**Suspension Springs - Use of Packers/Spacers**MODEL 2000 MY-ON  
S-TYPE

VIN L00001-ON

ILLUSTRATION 1

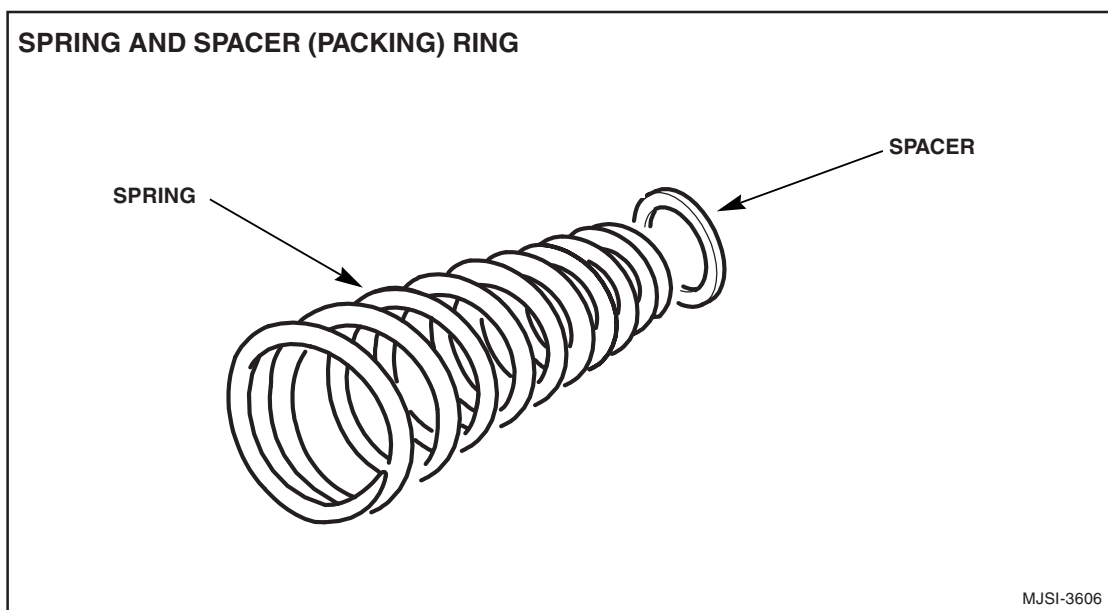
When short-tolerance springs are used in suspension assemblies, a 3 mm spacer (packing) ring is inserted under the spring, to maintain the correct ride height of the vehicle. **No** spacer ring is used with long-tolerance springs. Any one vehicle can be factory-equipped with any combination of long-tolerance and short-tolerance springs as original equipment.

**All** replacement springs supplied by Jaguar Parts are long tolerance springs that do **not** need spacer rings.

When installing a replacement spring on an S-TYPE vehicle, examine the existing condition.

In any location where a 3 mm spacer ring is found under the existing spring, discard the spacer ring before installing the **replacement** spring.
